AW-97-1118

June 10, 1997

SUBJECT: RESPONSES TO OPEN ITEMS ON WCOBRA/TRAC APPLICABILITY TO
AP600 LARGE-BREAK LOSS-OF-COOLANT ACCIDENT

Open Item - 4700

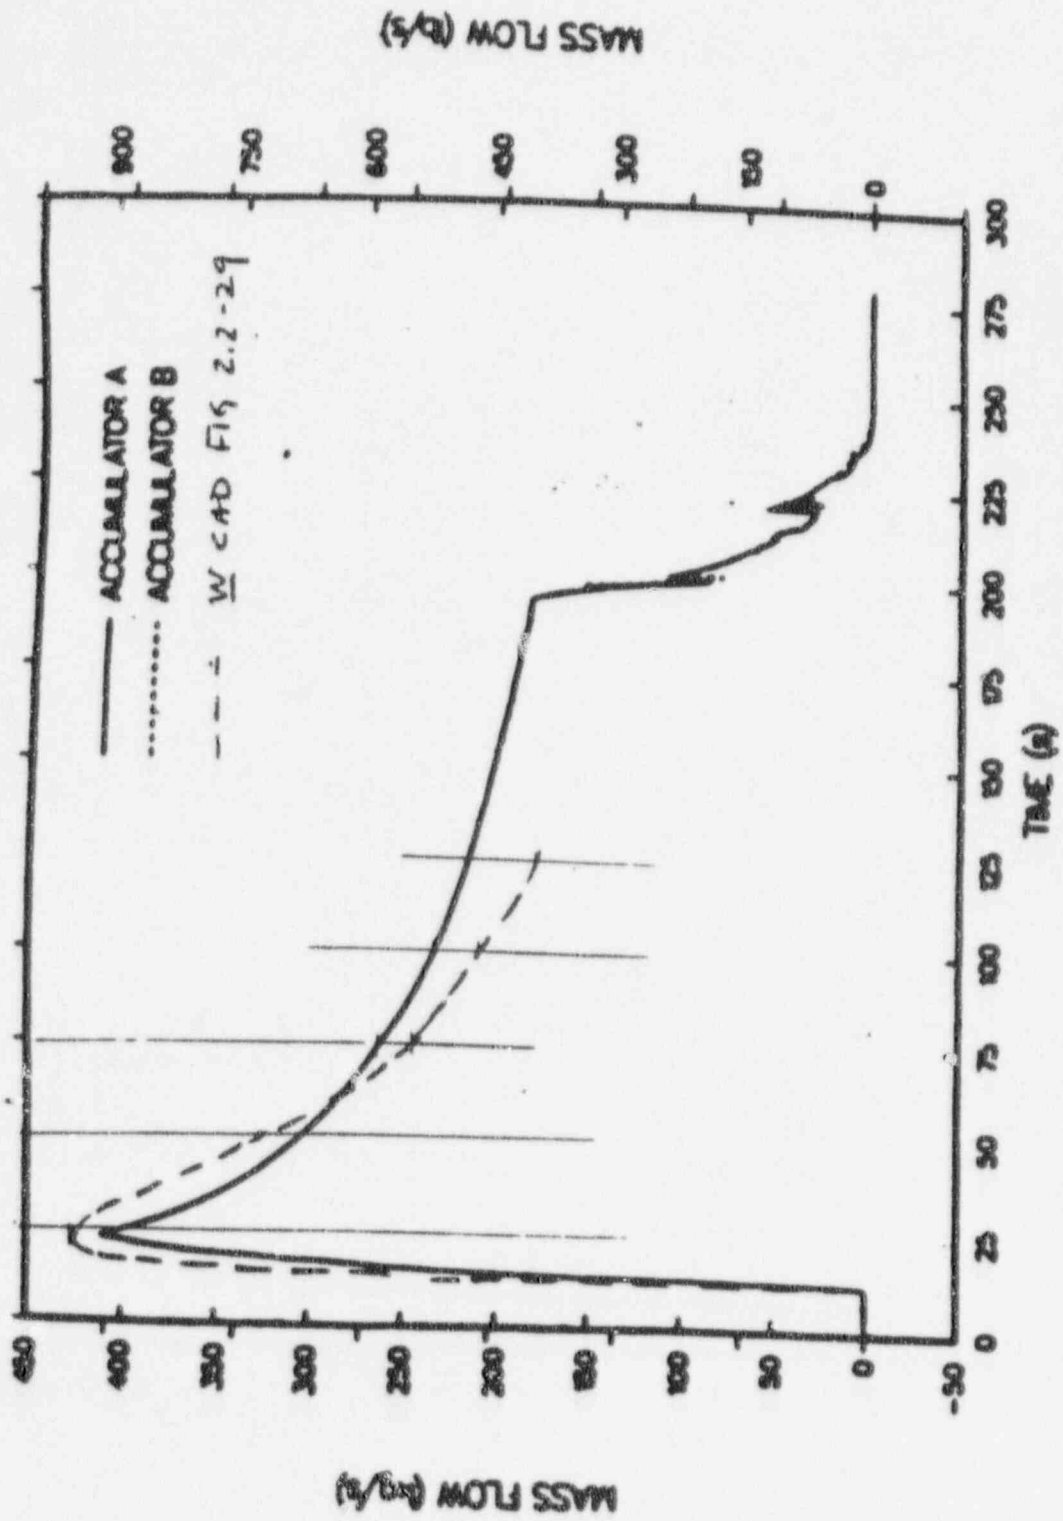
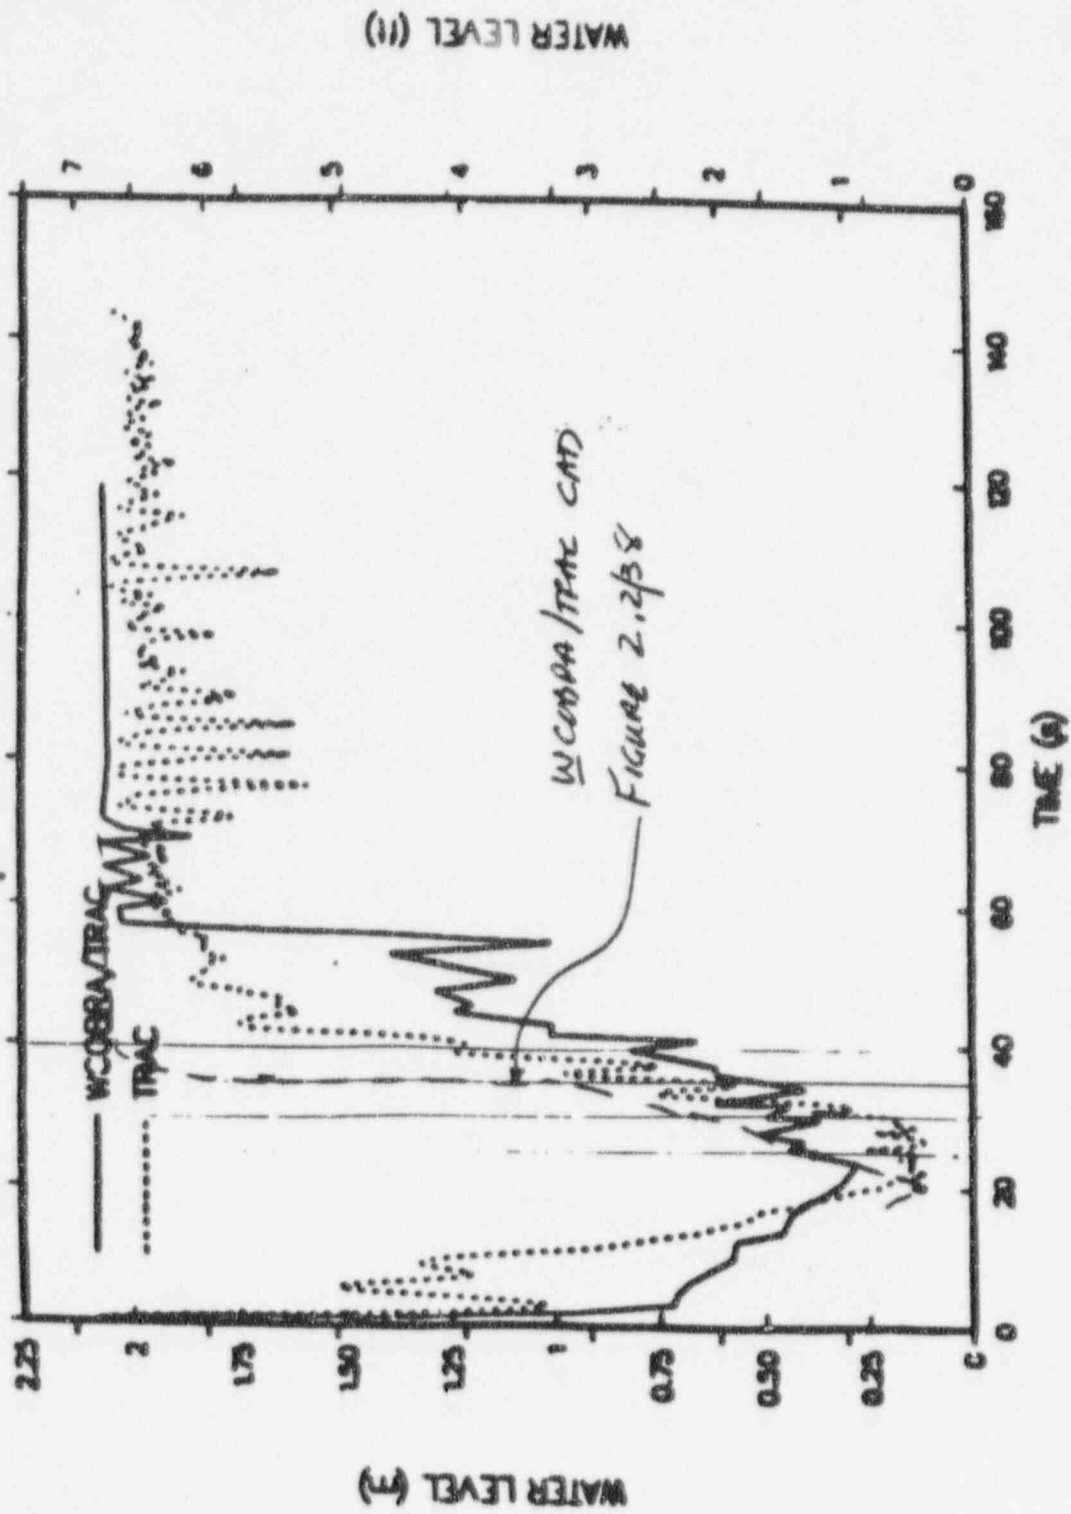
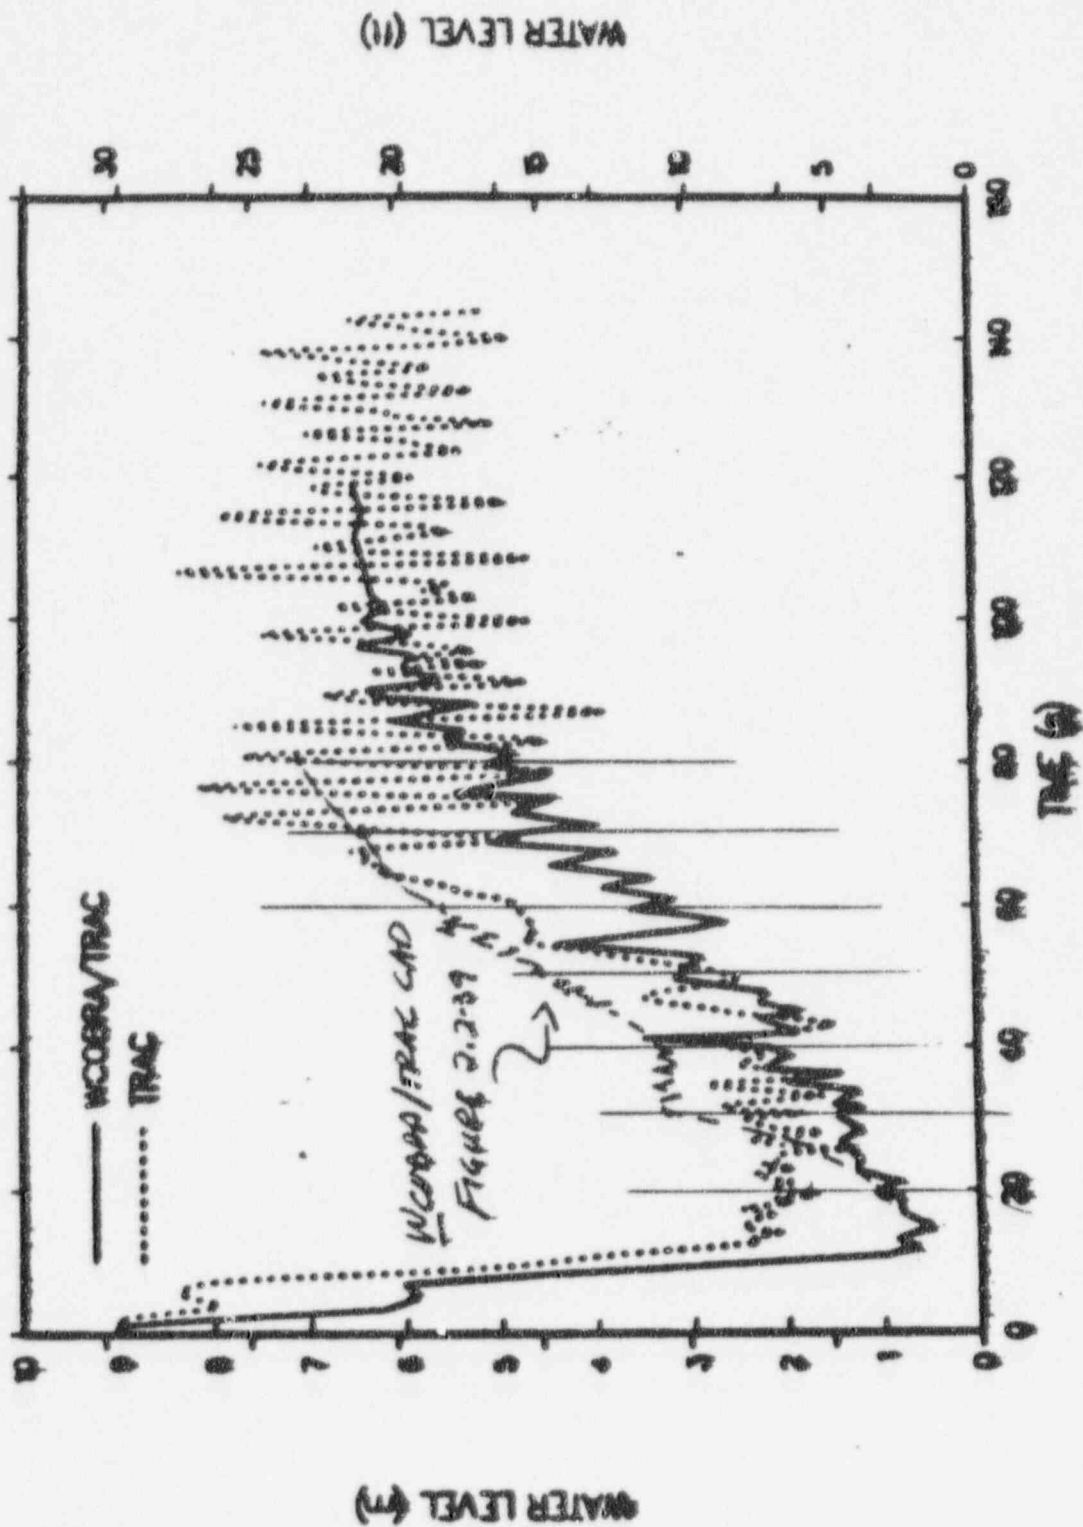
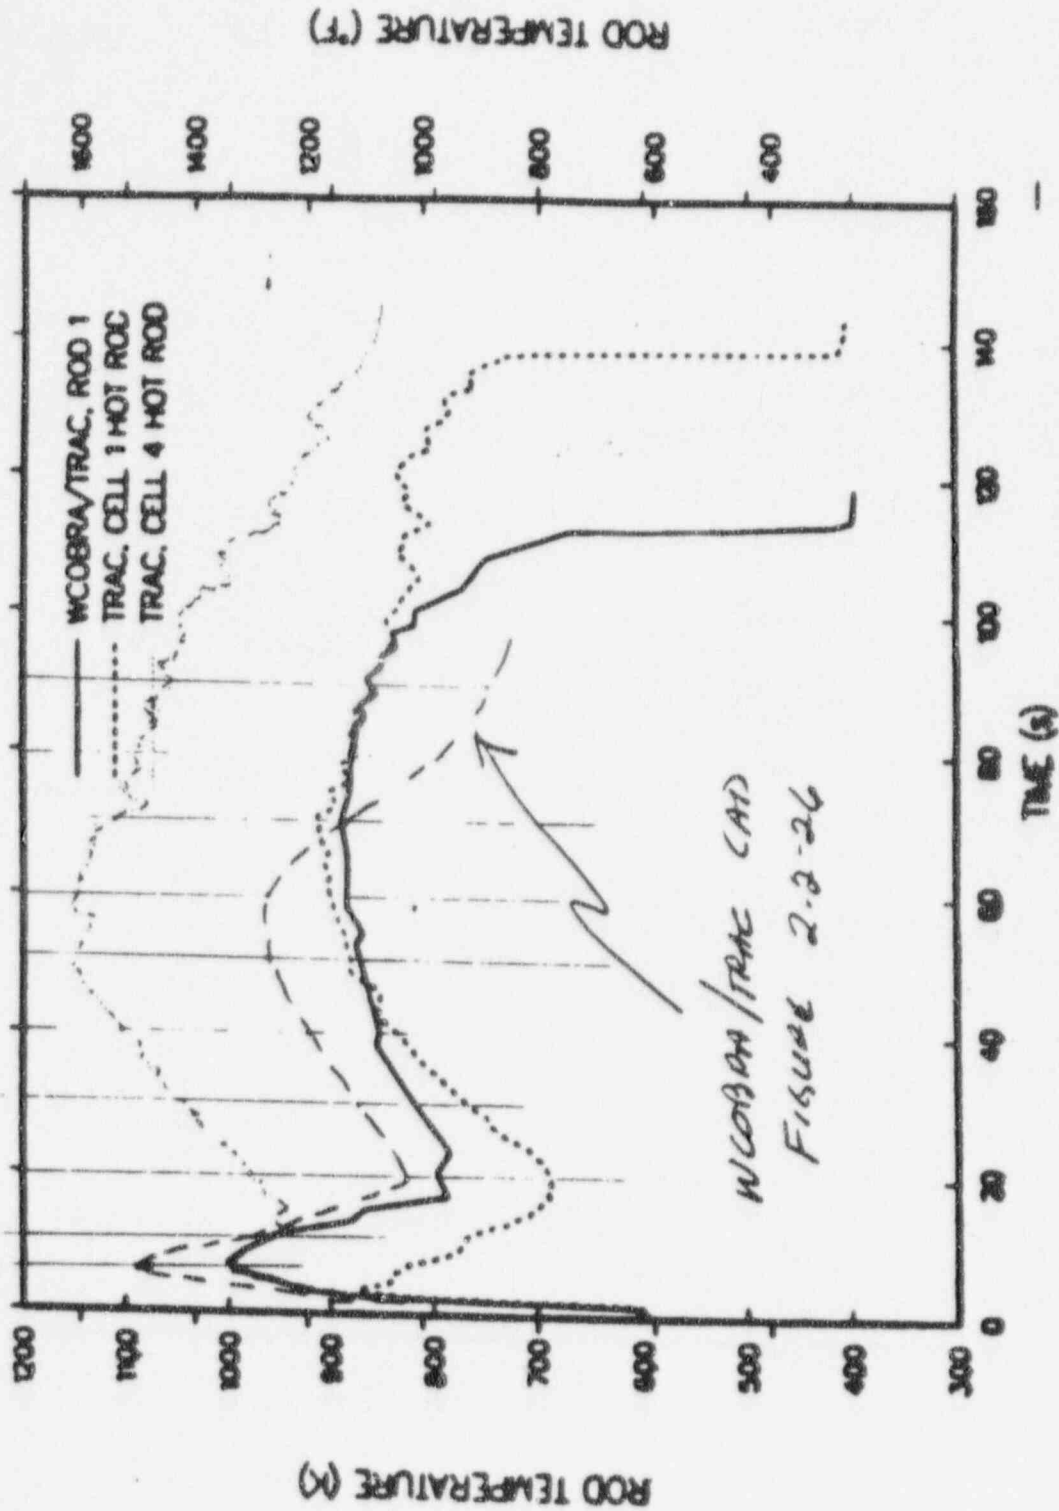
- (c) Are the reflood differences affected by the blowdown cooling differences discussed in RAIs 440.585 and 440.586? If yes, does the calculated reflood PCT difference impact Westinghouse's response to those RAIs or indicate the need to consider other models or phenomena to include the AP600 uncertainty evaluation.

- (d) Even accounting for the blowdown cooling differences, there is still approximately 180°F difference in reflood PCT. Can Westinghouse offer any information that may explain the reasons for this difference? Are models and phenomena that affect this reflood PCT difference accounted for in Westinghouse's AP600 uncertainty methodology? If yes, clarify how. If not, justify why not.

The reflood differences are given in parts (a) and (b) above. They are due to the difference in the accumulator behavior as well as the effects of spacer grids to improve the predicted heat transfer.

The explanation for the differences is given above. The effects of the grid modeling are included in the ranging of blowdown and reflood heat transfer, which is based on tests which cover the calculated AP600 conditions and also includes rod bundle data which includes reactor-type spacer grid (G-1 and G-2) blowdown tests, as well as the ORNL film boiling tests and the G-2, FLECHT-SEASET, and FEBA reflood tests. The uncertainty of these models is included in the calculated code uncertainty as well as in the AP600 ranging calculations. Furthermore, the AP600 SSAR large break LOCA analysis uses bounding accumulator input parameters to minimize the delivery of water and extend the predicted reactor vessel refill time.
